Access Compliance Report

Public Rights-of-Way

Intersection ID: N/A	Main Street: PROVIDENCE_RD	Cross Street: SOUTHGROVE_ST	Location: NE
ADA ID: 4DC815150ADD	Ramp Type: PerpDiag	Initial Pass/Fail: Fail	Overall Compliance: No
		Severity Score: 8.75	
Codes/Mitigation Info/Possible Solution		Field Measurements/Component Compliance

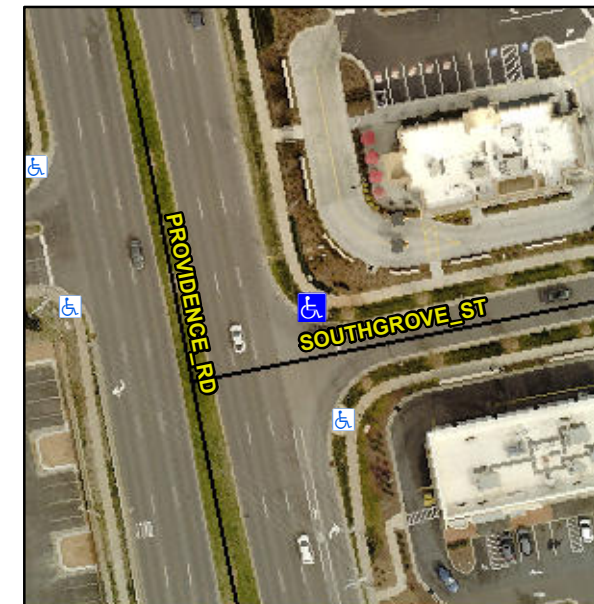
Not Found, R304.5.1

Compliance	Description	Data	Compliance	Description	Data
N/A	Ramp Length (in)	95.0	Yes	Ramp Slope (%)	5.4
No	Ramp Width (in)	47.0	Yes	Ramp XSlope (%)	1.4
N/A	Flare Type LT	N/A	N/A	Flare Type RT	N/A
N/A	Flare Slope LT (%)	N/A	N/A	Flare Slope RT (%)	N/A
N/A	Flare Traversable LT?	N/A	N/A	Flare Traversable RT?	N/A
N/A	Landing Length (in)	N/A	N/A	DWS Provided?	N/A
N/A	Landing Width (in)	N/A	N/A	DWS Contrast?	N/A
N/A	Landing Slope (%)	N/A	N/A	DWS Length (in)	N/A
N/A	Landing X Slope (%)	N/A	N/A	DWS Full Width?	N/A
N/A	Landing Curb? (Y/N)	N/A	N/A	DWS Offset (in)	N/A
N/A	Shared Landing?	N/A			
N/A	Gutter Ponding?	N/A	N/A	Gutter Slope (%)	N/A
N/A	Gutter Lip Ht (in)	N/A	N/A	Gutter X Slope (%)	N/A
N/A	Painted X Walk1?	No	N/A	Painted X Walk2?	No
	X Walk 1 Direction	To W		X Walk 2 Direction	To S
N/A	X Walk 1 Width (in)	N/A	N/A	X Walk 2 Width (in)	N/A
	X Walk 1 Slope (%)	0.5		X Walk 2 Slope (%)	2.3
	X Walk 1 X Slope (%)	2.2		X Walk 2 X Slope (%)	1.1

Remove & Replace Curb Ramp With Two New Directional Ramps or Equivalent.
